July 29, 2008

**SUBJECT: Denison Mines (USA) Corp. (DUSA)
White Mesa Uranium Mill Cell 4A Operation
Record of Telephone Conversations and Request for Information**

I. July 16, 2008 DUSA Cell 4A BAT Monitoring, Operations and Maintenance Plan:

II. Observed Construction Deficiencies:

SECTION
SLIMES DRAIN HEADER
SCALE: 1" = 1'

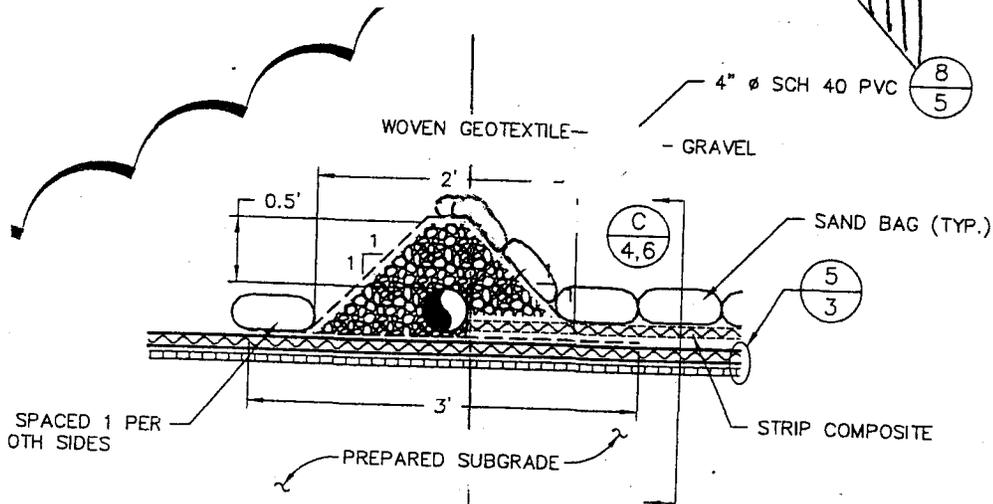
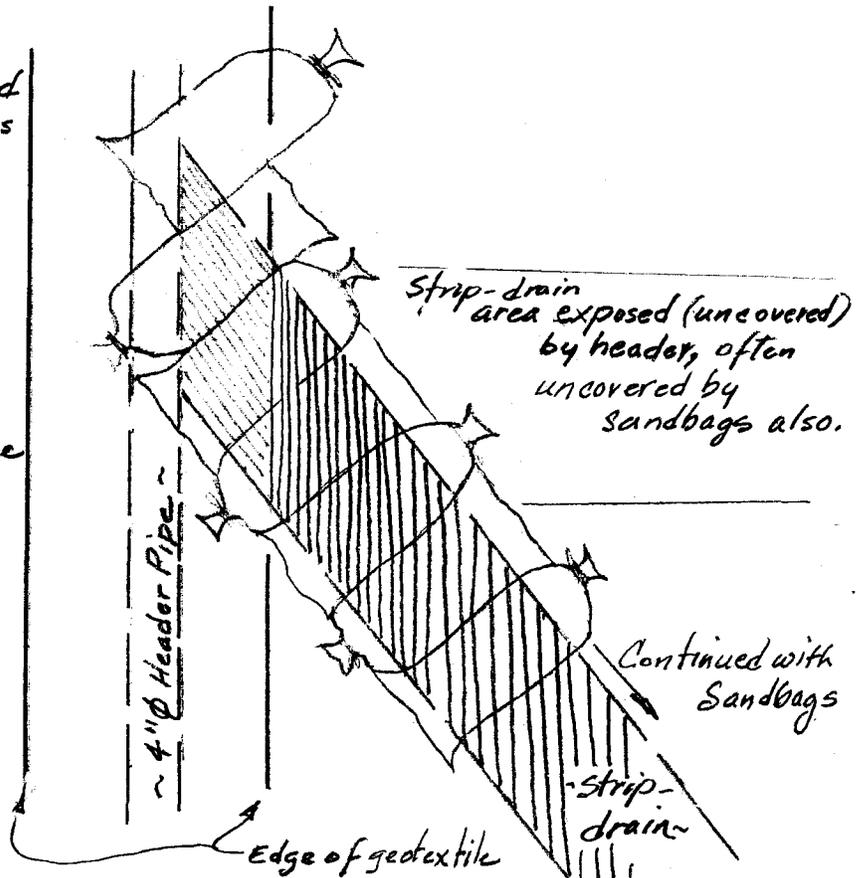
- a.) Sandbag Cover over the Strip-drains:
 - 1.) Sandbags which expose the strip-drain need to be adjusted to cover the same at all locations.
 - 2.) The exposed strip-drains at their junctions with the slimes drain header need to be properly covered with sandbags.
 - 3.) Sandbags need to be extended onto the slimes drain header windrow to cover and be in alignment above the slimes drain sections that are installed within the slimes drain header envelope of geotextile and gravel drain rock. See attached DRC sketch dated July 25, 2008.

Strip-drain Area currently to be covered by sandbags for filter as req'd by specs.

Strip-drain area to be covered by sandbags and header envelope

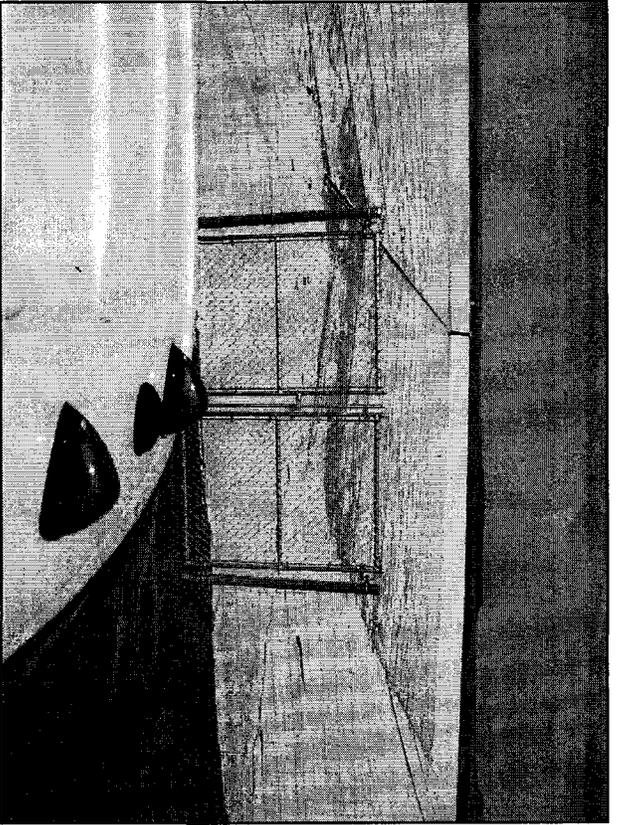
Photo 3. Realigned sandbags. Note gaps at underside between the two center bags.

Photo 2. Connection of fabrics between sandbag ballast, slimes drain backbone. Note rock exposed, but not on the liner.

Photo 4. Line of strip-drain bags. Reduction in gaps noted since last site visit. However, some still present necessitating more adjustment required.

Photo 5. Note opening in black fabric slimes drain header allowing small amount of drainage rock to escape. Escaped rock needs to be removed or enveloped in fabric.

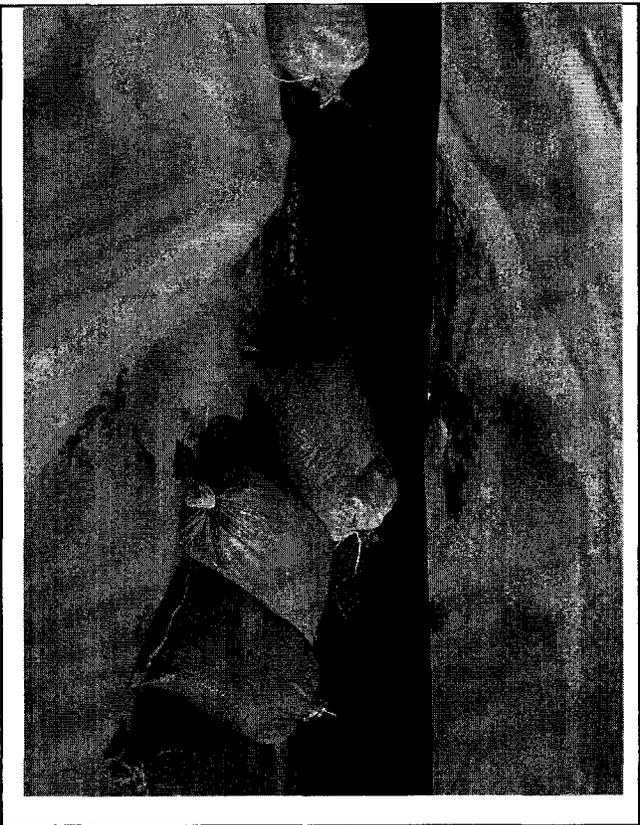
Photo 7. Not enough bags to cover exposed strip-drain... Use of additional bags to cover and filter the slimes moving vertically through the header to the strip-drain within the black envelope was discussed. Also see photo 6 and 8 for rough idea.

Photo 6. Note exposed strip-drain. Use of sand bags to cover and filter slimes moving vertically through the header to the strip-drain within the black envelope was discussed. See photos 7 & 8.

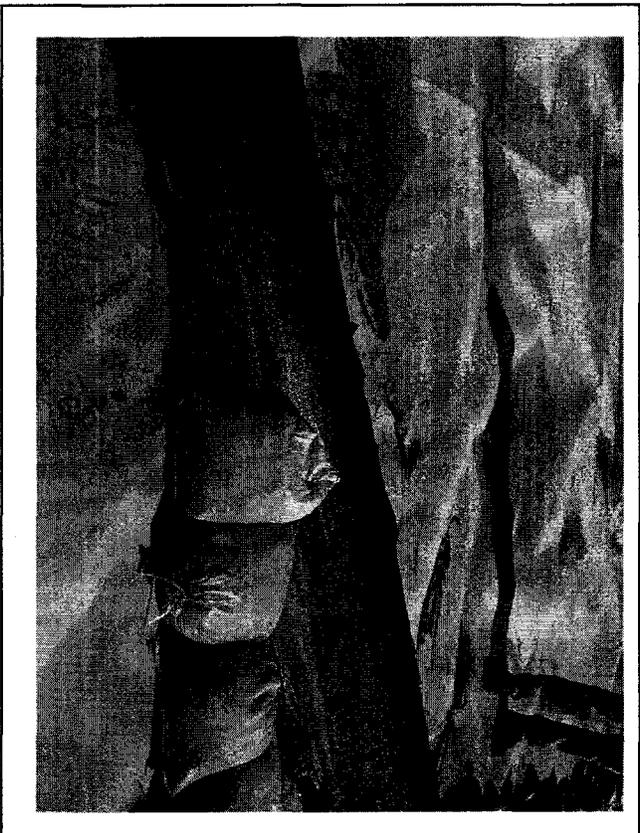
Photo 8. Similar to previous. Drawing showing coverage of strip drain within the header by sandbags above the black header is provided separately.

Photo 9. Similar problem. Bags not covering strip-drains all the way to junction. Note storm water collected in S.W. corner of tailings cell.

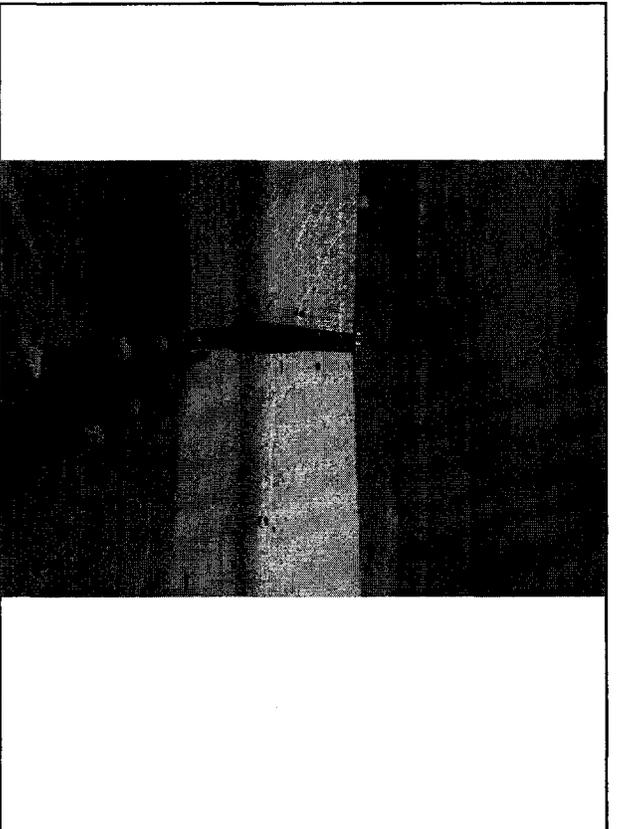
Photo 10. Black header drain daylighting from storm water.

Photo 12. Black fabric envelope width meets the specifications, but the specified rock configuration cannot always be contained completely by the envelope.
